Item Name: Crosstube Aft

Draw Nbr	Revision Nbr
D212-664-241	Rev D (DEO)
DSI9563

DRAWING NO. D212-664-241	TITLE CROSSTUBE ASSY (205/212 HI AFT)	REV. D	DART AEROSPACE LTD ENGINEERING ORDER		D.E.O. NO. D212-664-241-D-1	SHEET NO. SHEET 1 OF 2	SCALE NTS
DRAWN	CHECKED	MFG. APPR.	APPROVED	DE APPR.			
DATE 11.04.07	DATE 11.04.11	DATE 11.04.12	DATE 11/04/12	DATE 11.04.12

DRAWING NO. D212-664-241	TITLE CROSSTUBE ASS'Y (205/212 HI AFT)	REV. D	DART AEROSPACE LTD ENGINEERING ORDER		D.E.O. NO. D212-664-241-D-2	SHEET NO. SHEET 1 OF 1	SCALE NTS
DRAWN 97	CHECKED ASS	MFG. APPR. [Signature]	APPROVED [Signature]		DE APPR. [Signature]		
DATE 11.07.15	DATE 11.07.20	DATE 11.07.21	DATE 11/27/21		DATE 11.07.21

D212-664-241/-241B
ASSEMBLY DETAIL

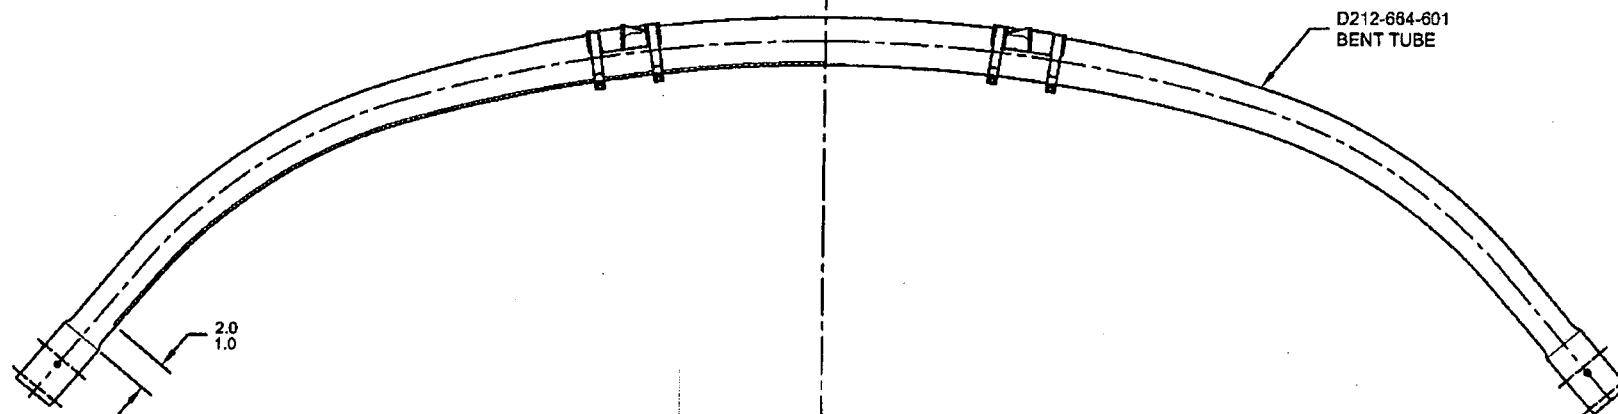
ADD AN INSPECTION WINDOW TO UNDERSIDE OF CROSSTUBE.

- 2) FINISH: CHEMICAL CONVERSION COAT PER DART QSI 005 4.1
PRIME INSIDE AND OUTSIDE PER DART QSI 005 4.2
MASK UNDERSIDE OF CROSSTUBE AS SHOWN (HATCHED AREA) AND
PAINT OUTSIDE PER DART QSI 005 4.2
REMOVE MASKING AND APPLY CLEAR COAT

- 2) FINISH: CHEMICAL CONVERSION COAT PER DART QSI 005 4.1
PRIME INSIDE AND OUTSIDE PER DART QSI 005 4.2
PAINT OUTSIDE PER DART QSI 005 4.2

MASK AREA PRIOR TO PAINTING,
REMOVE MASKING AFTER PAINT
AND APPLY CLEAR COAT

FIGURE 1: SUPPORT INSTALLATION

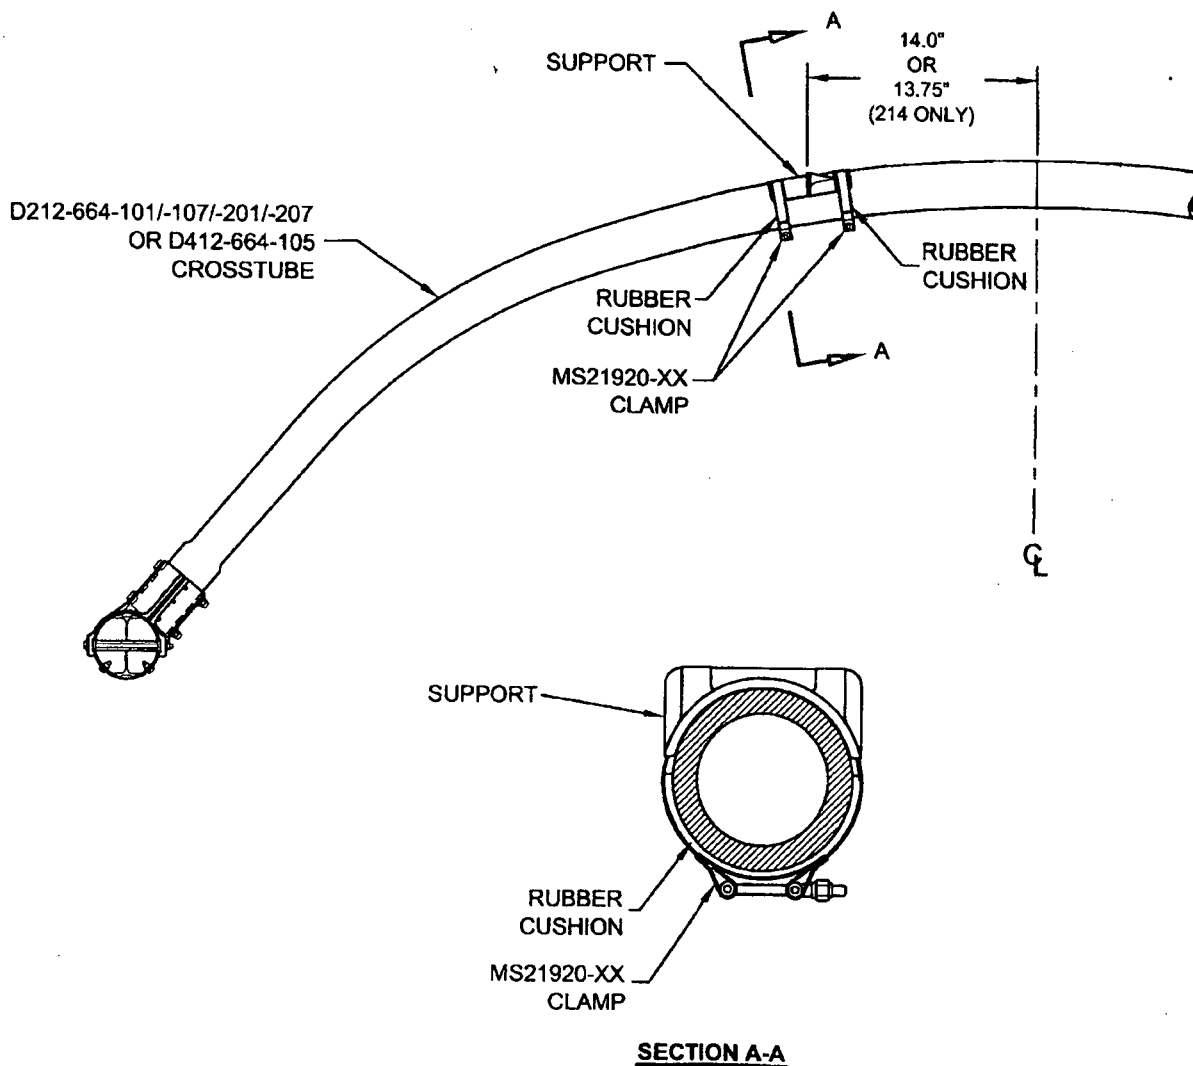
PURPOSE:
REPLACE MAGNOBOND WITH PROSEAL.

- 32.4.5 Apply a 0.04" to 0.07" thick layer of Proseal 890 Class B or AMS-S-8802 Class B sealant underneath applicable support and install support as shown in Figure 1 of this service instruction.

- 32.4.6 Install the clamps opposite to crosstube support as shown in section A-A of Figure 1. Install rubber cushions underneath each clamp around the bottom circumference of the crosstube up to the crosstube centerline. Torque clamps 80-100 in-lb (9.0-11.3 Nm). It is acceptable to use smaller or larger sized MS21920-XX clamps than those listed in ICA-D212-664, ensure that after torquing the clamps per this instruction, the nuts are in safety but not bottomed out.

Acceptability of 8% CRUSHING

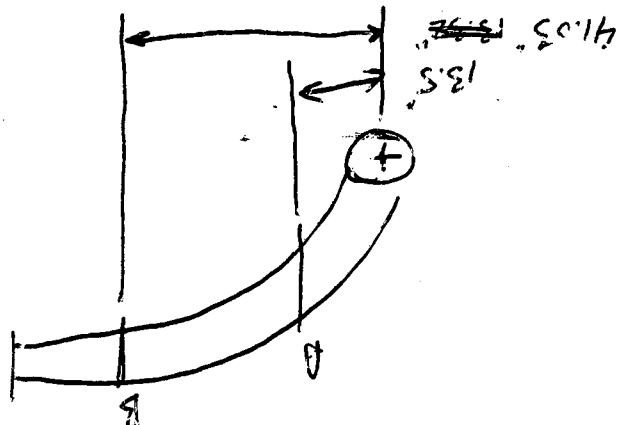
(CRUSHING OF D212-664-201

Point A: $OD = 2.548$ in $OD = 2.442$ in
 CRUSHING $(2.442 - 2.548) / (2.442 + 2.548) = 8\%$
 $I = 1.476$ in⁴

NCR:		WORK ORDER NON-CONFORMANCE (NCR)						
DATE	STEP	Description of NC Section A	Corrective Action Section B			Verification Section C	Approval Chief Eng	Approval QC Inspector
			Initial Chief Eng	Action Description Chief Eng	Sign & Date			
12.05.31	120	Tube is bent high. CRUSHING OVER TOL.	 12.05.31 	Acceptable per attached SR	 12/05/31	 12/05/31	 12.05.31 	 12/05/31
